Responses to Interrogatories

EB-2016-0105

Figure 2 - Weibull Probability of Failure Curves

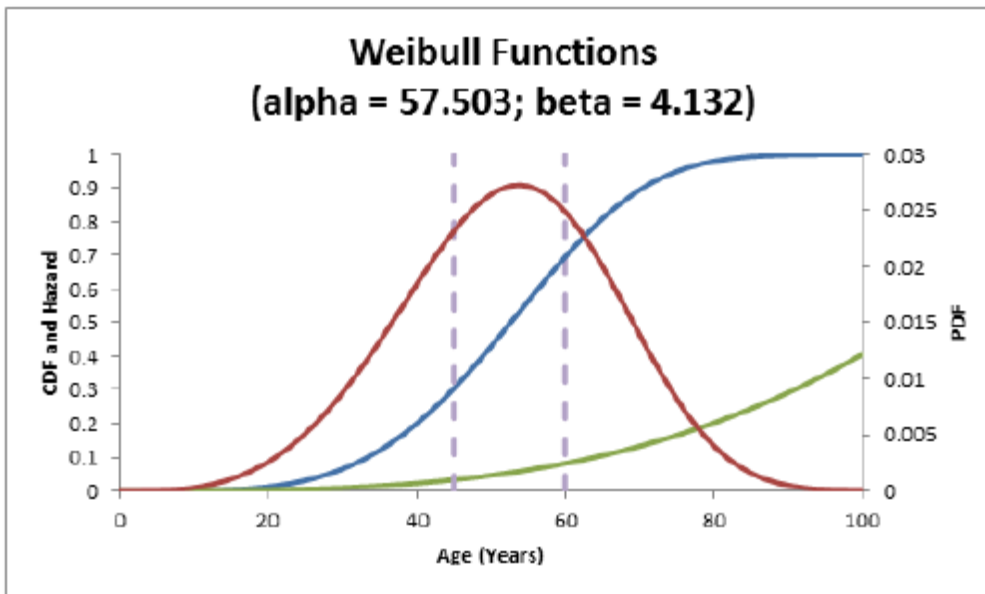
- a) Please quantify the ratio of the missing Thunder Bay Hydro removal data as a percentage of a complete data set, where 100% indicates that all required removal data is available, and 0% indicates that none of the required data is available.
- b) How important is removal data when calculating utility-specific Health Index ("HI") values?
- c) To what extent does depending upon the opinions of experienced staff in the absence of complete actual removal data impact the confidence intervals associated with HI values? Please quantify.

d) Are removal data typically categorized by driver, e.g.: does removal data separately track storm-induced failures, electrical failures, tree-fall failures, vehicle accident failures and premature retirements due to customer requests (such as road widening or business closures)?

- a) Removal data was not used in the HI calculation.
- b) It is needed for linking HI with the corresponding probability of failure
- c) The opinion of experienced staff is important in establishing Typical Useful Life for assets, whereas demographics are used to determine Extreme or Maximum Useful Life. It is impossible to quantify the impact of this approach verses using actual removals statistics.
- d) Ideally, removal data is required to identify removals driven by condition only and they include actual failures and removal of assets in poor condition before they fail, for economic reasons.

Figure 3 – TBHEDI's 10-Year FFAP

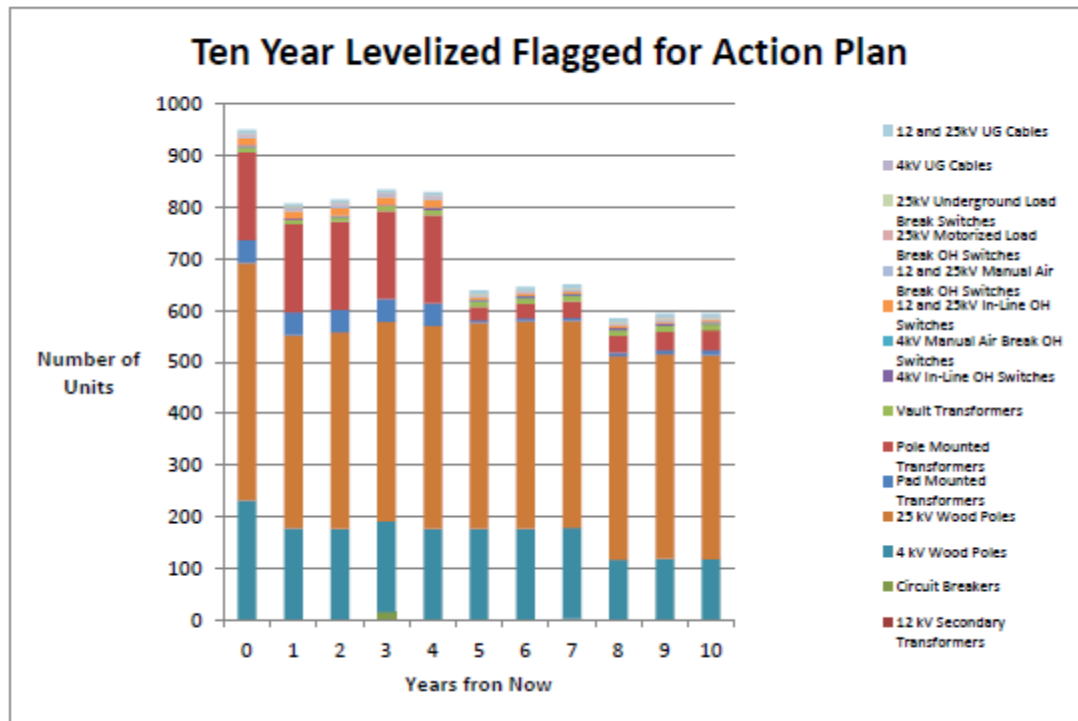
- Please explain the reasons for the significantly higher number of units flagged for action during the first five years (year 0 to 4) shown in Figure 3, and particularly the number of units in year 0. Please quantify the explanation, to the extent possible.

- Does the Flagged-for-Action Plan (FFAP) shown in Figure 3 incorporate the asset replacements forecast in the present filing? If not, please provide an updated version of Figure 3 that does incorporate the forecast replacements.

- What would be the anticipated reliability impacts of implementing a replacement program that was more evenly paced over the planning horizon shown in Figure 3?

- Please compare the FFAP with historical replacements for the 5 year period immediately prior to year 0 in Figure 3.
- Please explain the reasons for any significant (>10%) inter-annual unit flagged for action counts over the historical and planned horizons, by asset class.

- a) The number of units flagged for action is derived from HI and generated failure curves as described in the Kinectrics ACA report included in Exhibit 2, Attachment 2-I, Appendix C. For those that are proactively addressed, specific units are flagged for action once their POF exceeds 0.8. The units with only age data available have a number of units expected to fail each year estimated

without identifying specific units. Once this analysis was done, a five-year averaging was done or criticality considered in levelizing the FFAP.

The reason there are higher quantities flagged in the first 5 years is because it was found that there is a backlog of units that need to be addressed. i.e. larger quantities in very poor/poor condition that will translate to larger quantities to be addressed in the near future.

- b) The asset replacement forecast in the present rate filing incorporates FFAP is an input in representing condition driven replacement needs along with other drivers (see response to ER-Staff-79 a)) and not the other way around.
- c) Please see our response to ER-Staff-80 b)
- e) FFAP was developed for the first time in 2016 and represents condition based only replacement requirements. Historical replacements represent not only condition based replacements but also replacements for other reasons and, thus, should not be compared to the FFAP in the ACA.
